LINCOLN-LANCASTER COUNTY HEALTH DEPARTMENT

INDIVIDUAL SEWAGE SYSTEM CONSTRUCTION — TYPE OF PERMIT

FORM HD-41(73) APPLICATION FOR PERMIT TO ALTER, EXTEND OR REPAIR INDIVIDUAL SEWAGE DISPOSAL SYSTEM

REAL ESTATE TRANSFER/LOAN APPROVAL FORM

AS BUILT DRAWING OF SYSTEM

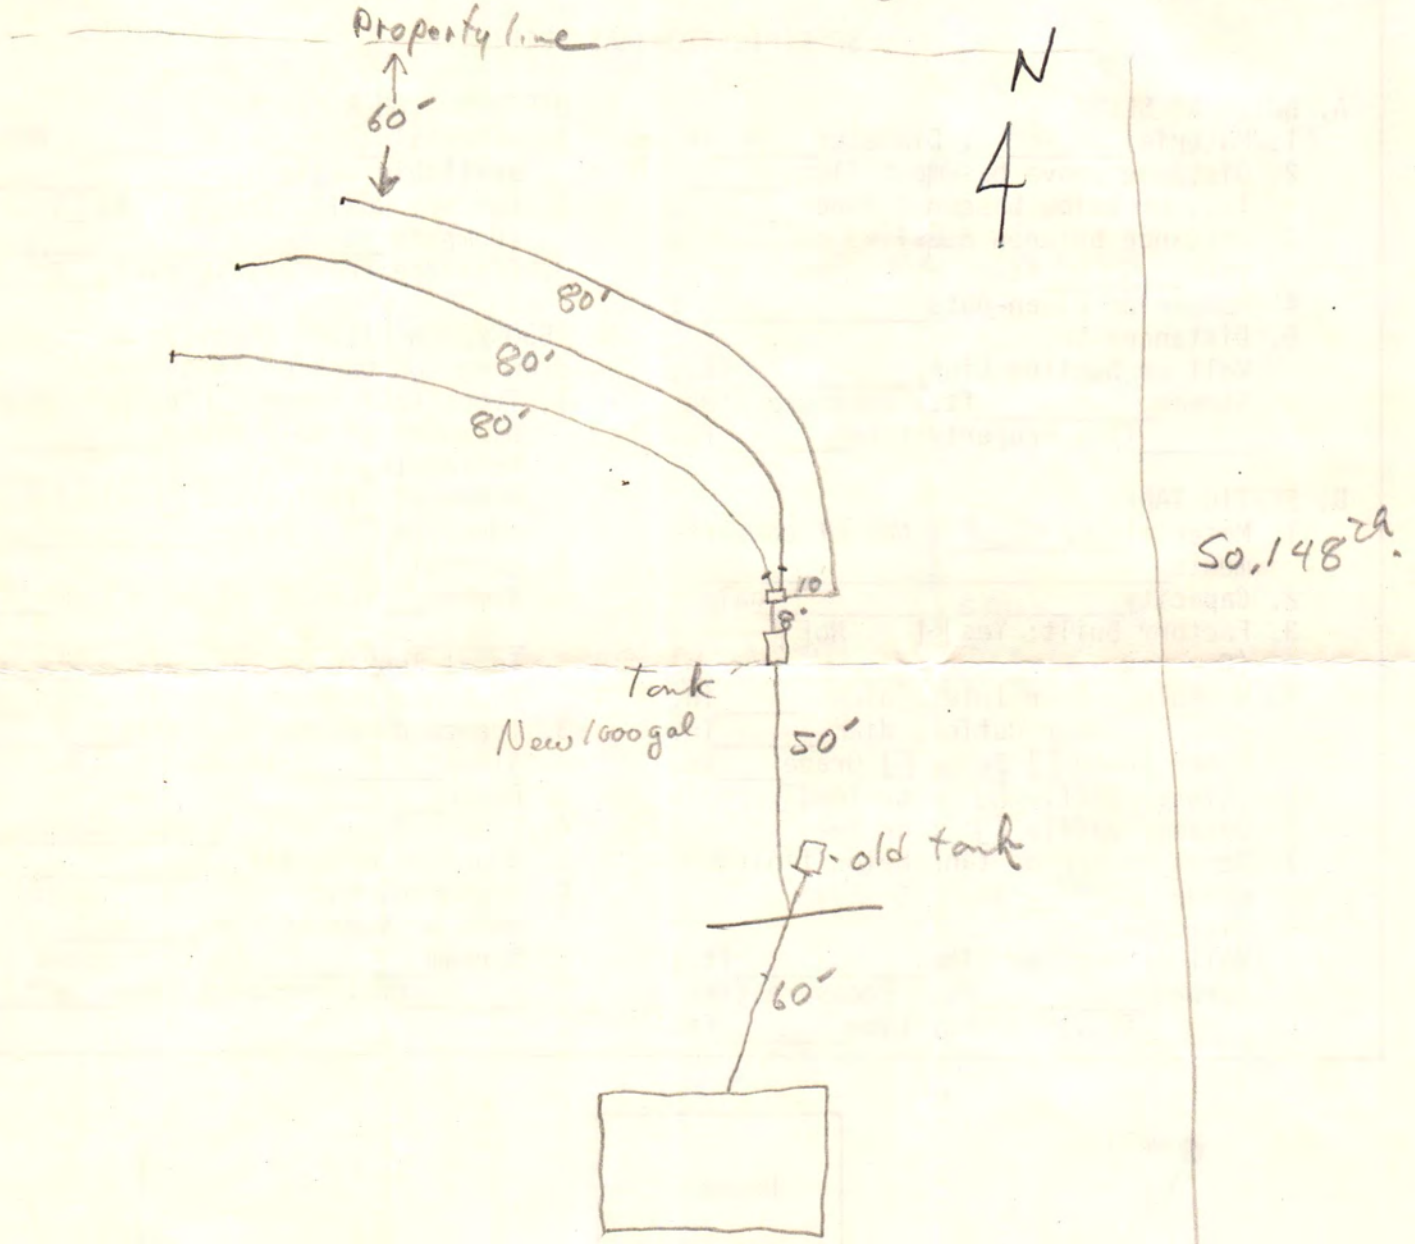
Comments: PROVISIONAL APPROVAL ON SEWAGE SYSTEM BECAUSE A PORTION OF IT (BUILDING SEWER) EXISTED PRIOR TO REGULATIONS. IF THE WELL UNDER THE WIND MILL IS NOT TO BE USED IT MUST BE PROPERLY ABANDONED. See Attached Letter ☐
